PROJECT
 17049
 407-411 KING STREET
 WEST MELBOURNE VICTORIA 3003

TP number	Description of Proposal	Decision & Date of Decision	Officer Comment
TP-2016-398	Partial demolition, buildings and works to construct a multi storey building to be used for the purposes of residential hotel, dwellings and licensed food and drink premises (restaurant and cafe licence) (excluding hotel and tavern) on ground level, reduction in car parking and bicycle facilities requirements, waiver of the loading bay requirements and construction and display of business identification signage	Refusal 13 April 2017	<p>Proposal sought approval to carry out partial demolition and construct a contemporary 19 level building above to an overall height of 69.4 metres.</p> <p>An application under Section 79 of the <i>Planning and Environment Act 1987</i> was lodged by the permit applicant at VCAT against Council's failure to grant a permit within the prescribed time.</p> <p>Council formed the view that had a failure appeal not been lodged, Council would have refused the application as a result of significant concerns raised relating to heritage, built form and design matters.</p>

On 27 April 2018, the applicant form

DRAWING TITLE
 LEVELS 10-17 FLOOR PLAN

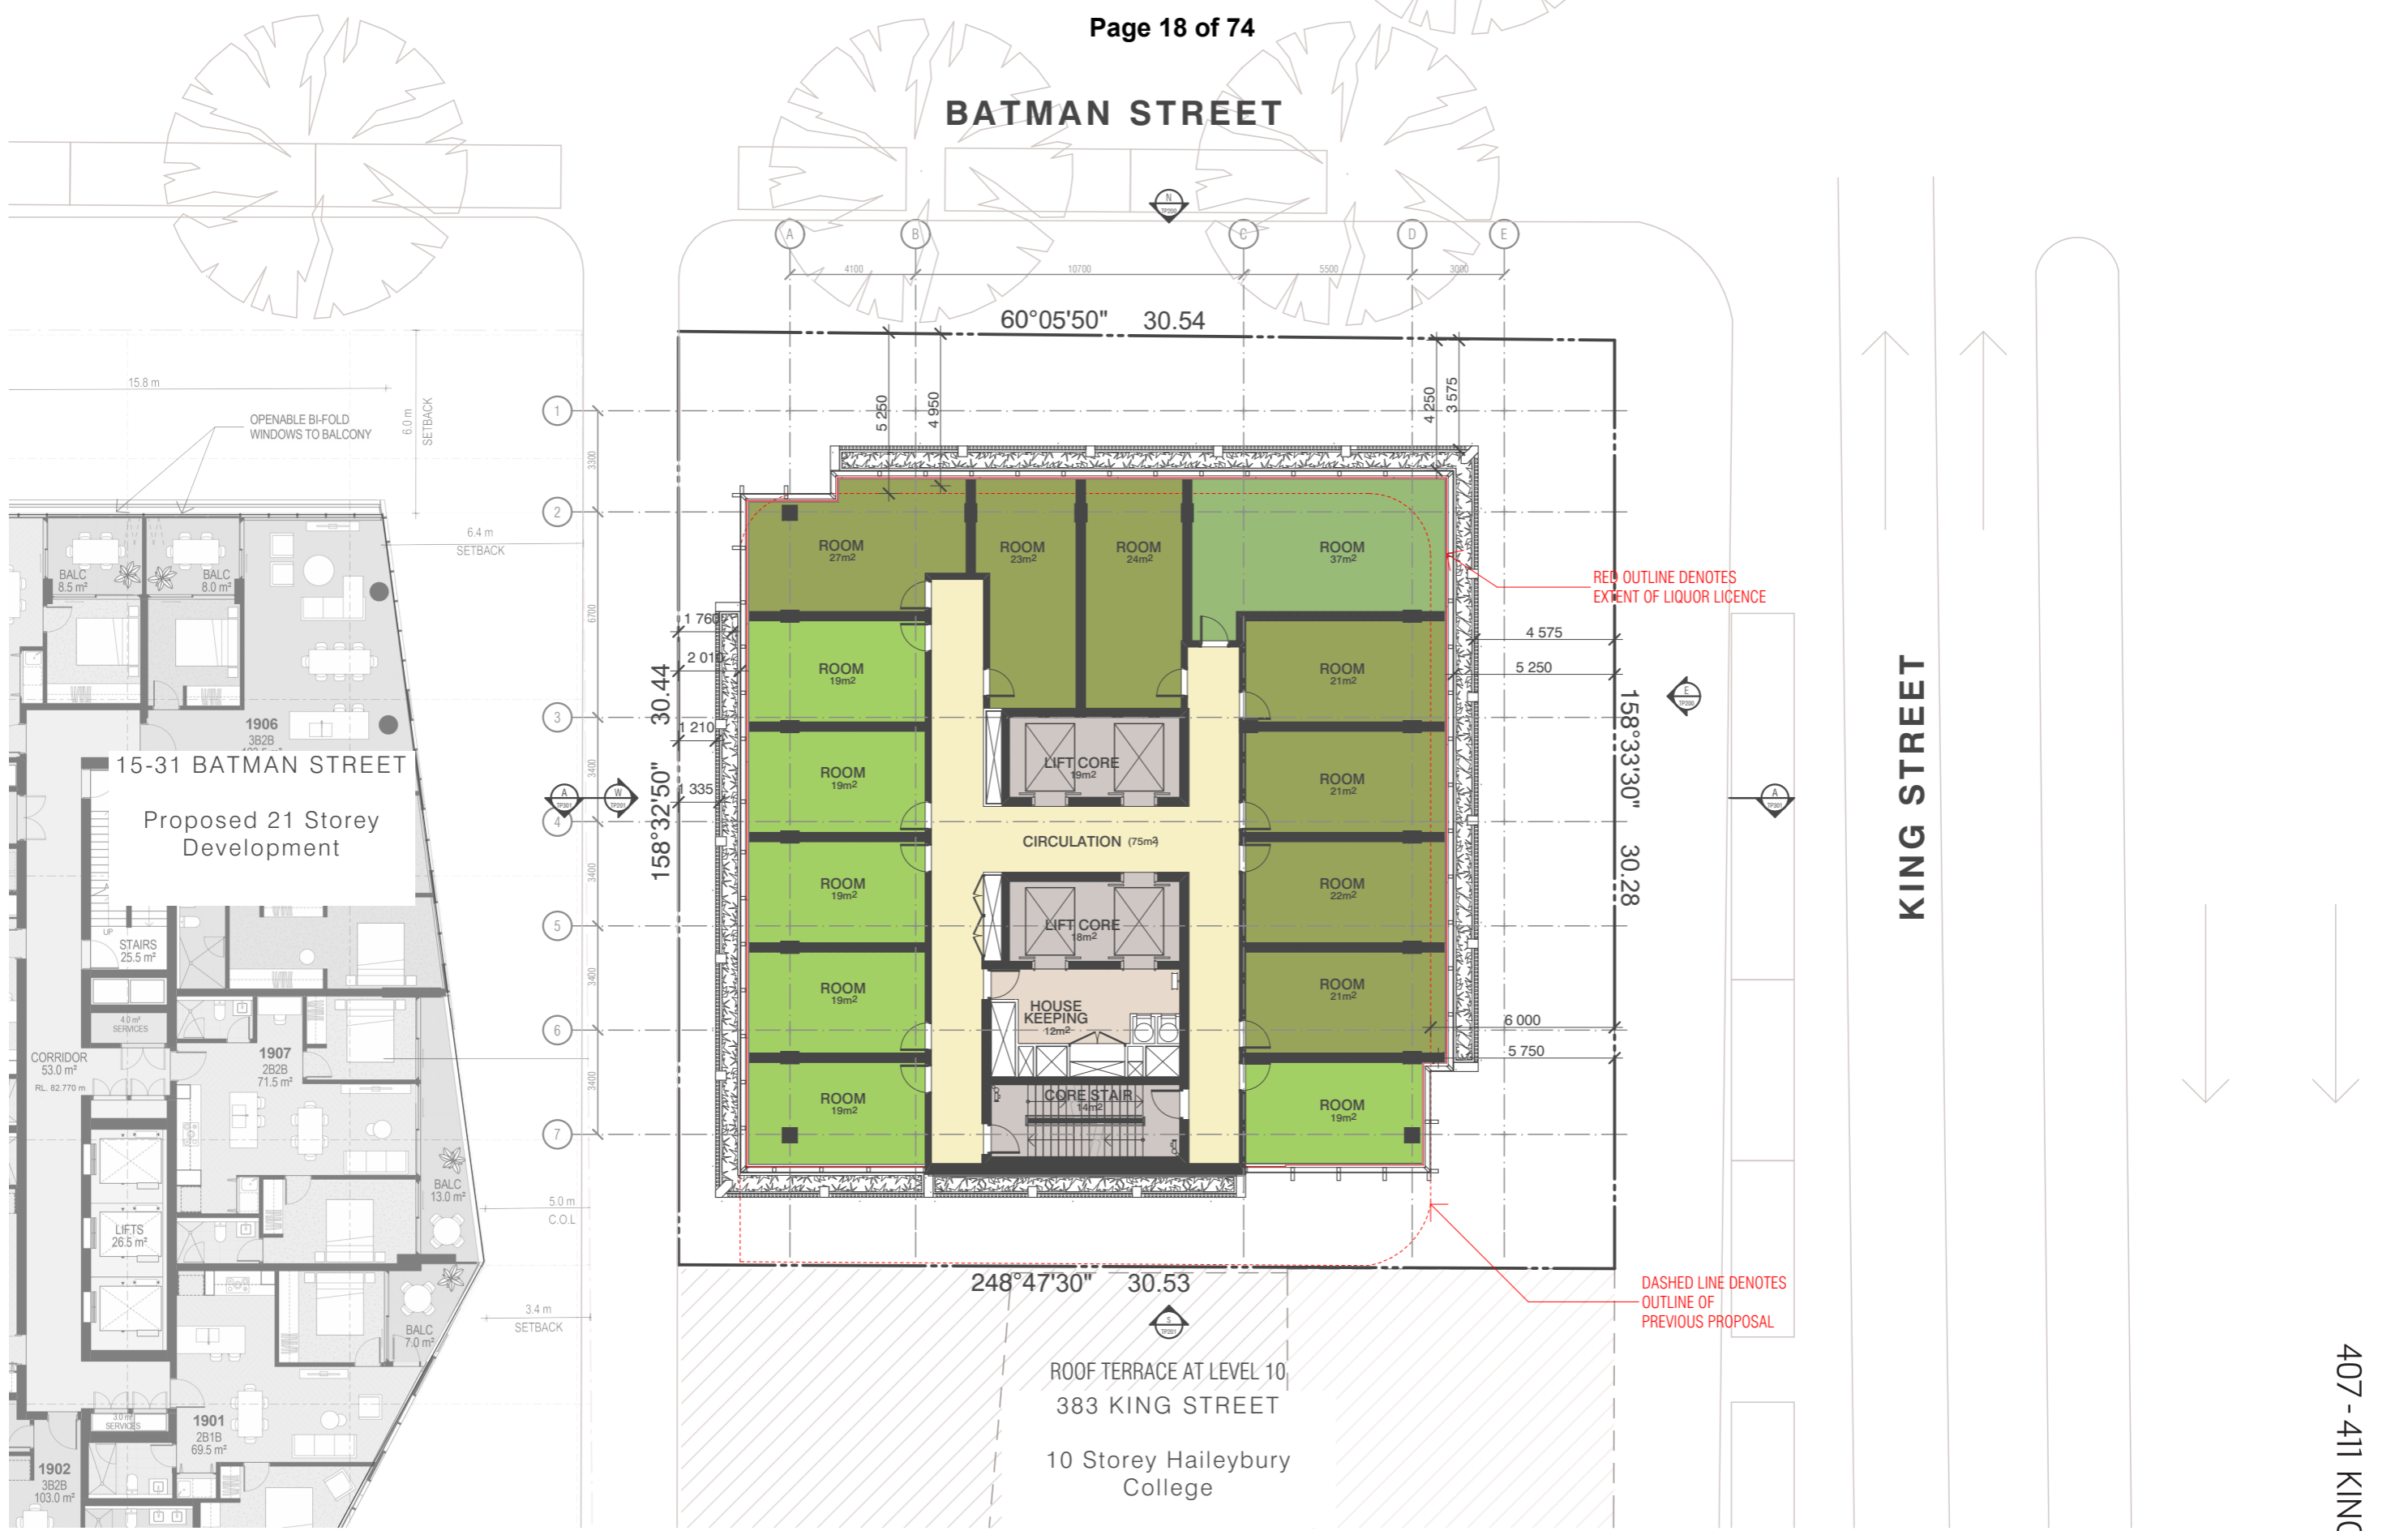
To the southern boundary, from levels 10 and above, the proposed tower behind the planter façade will be setback 3m from the boundary. VCAT, when considering the previous scheme, recommended a 50m high tower with a 3m setback from the southern boundary to limit amenity impacts on the school. This further justifies the recommendation to reduce the height of the proposed tower which would assist in minimising amenity impacts to the school's outdoor areas. This will be discussed in greater detail below.

The proposed tower has responded to this by providing a 3m setback on the upper levels (levels 10 and above) from the boundary to the building line. The southern elevation also incorporates a planter façade as per the front and side elevations thus being designed in the round and which also assists in minimising the bulk when viewed from the school’s outdoor areas.

DRAWN	DATE	CHECKED	PLOT DATE	JOB NO.	SCALE	DRAWING TITLE
SI	13.04.2018	AB	16.04.2018	17049	1:200@A3	LEVEL 18 FLOOR PLAN

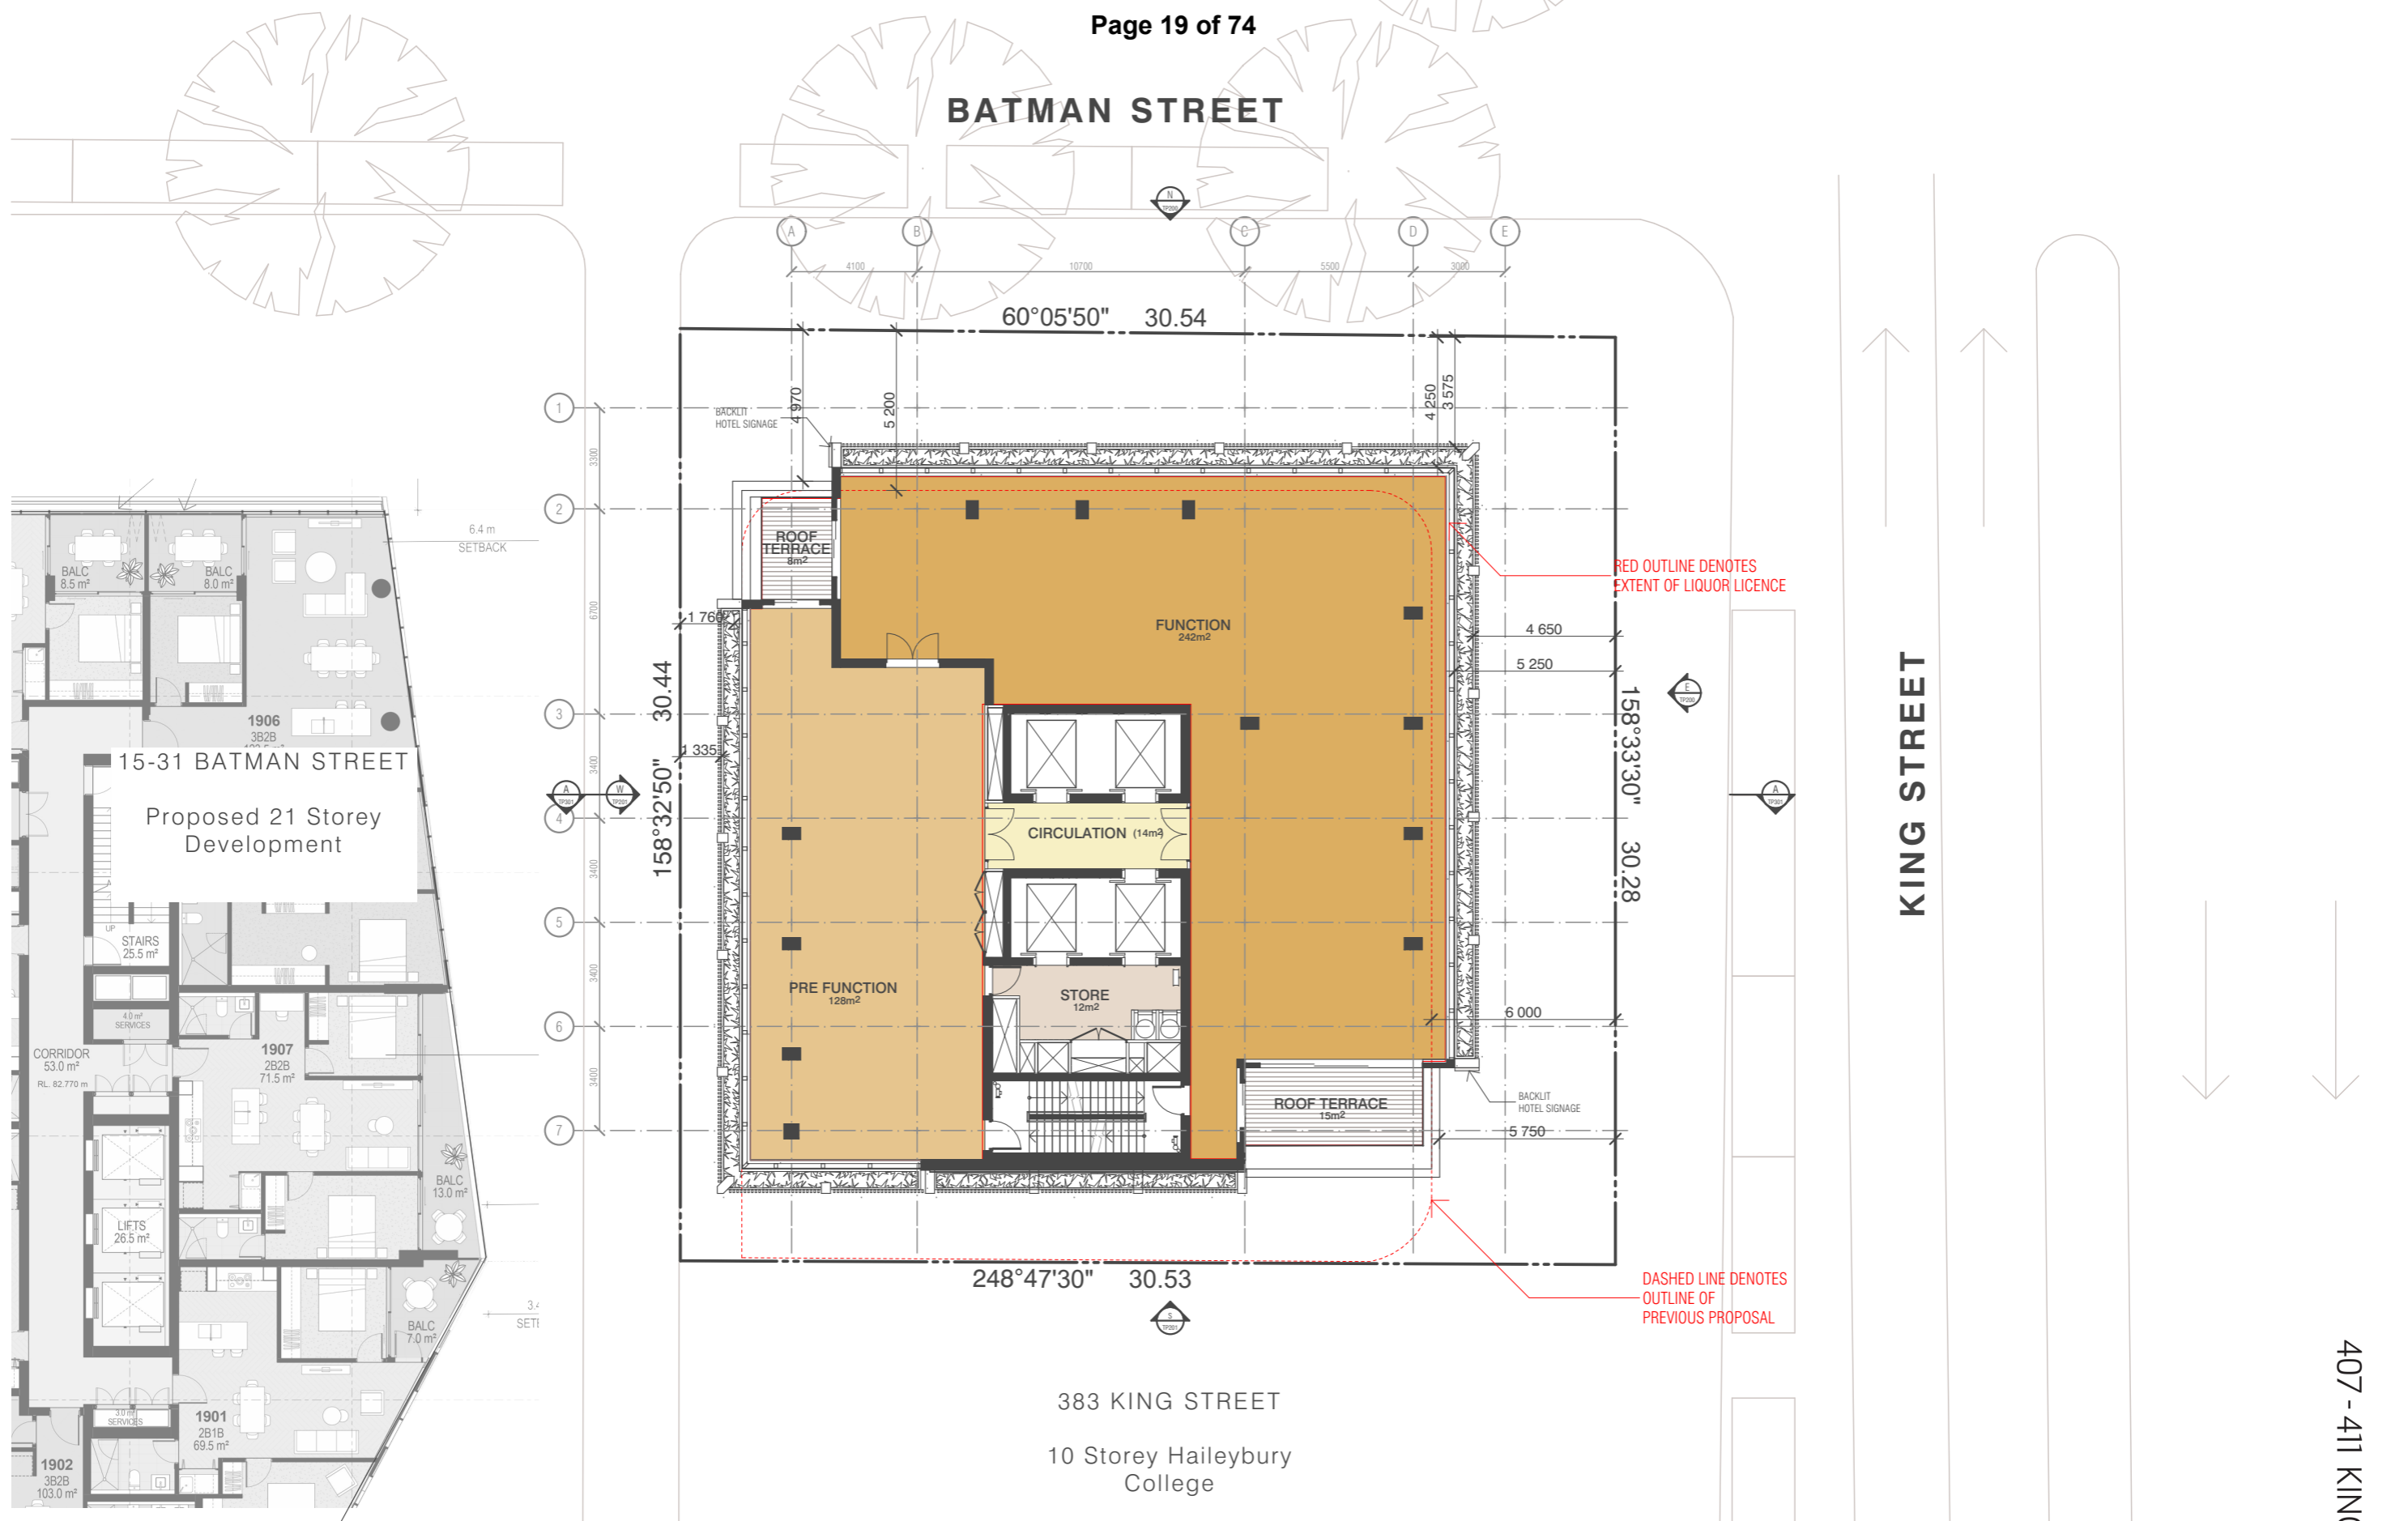
As depicted in figure 7 below, the licensed function centre use proposed on the rooftop comprises a pre-function space and outdoor spaces located in close proximity to sensitive uses; a residential apartment building located to the immediate west at 15 Batman Street, and the school located to the immediate south at 383 King Street.

It is proposed to consume liquor in these function spaces until 11pm and the maximum number of patrons allowed will be 255 at any one time. The 11pm closing time is consistent with the hours outlined in Clause 22.22. However, the policy discourages new licensed premises in the Mixed Use Zone where the predominant surrounding use is residential. While it can be argued that the surrounding uses are not predominantly residential, as mentioned above, the subject site has direct abuttal to a residential use.

The residents at 15 Batman Street have objected to the proposed function centre use. These adjoining dwellings have private balconies and habitable room windows directly interfacing the function centre. Concerns are raised with regards to the potential amenity impacts that the proposed function centre and associated on-premises licence may have on the neighbouring dwellings from the 255 patrons and the noise particularly in the outdoor terrace areas. The current application does not provide any details as to how patrons and noise will be managed to mitigate the amenity impacts to these adjoining sensitive uses. In addition, the internal layouts of these spaces are not shown.
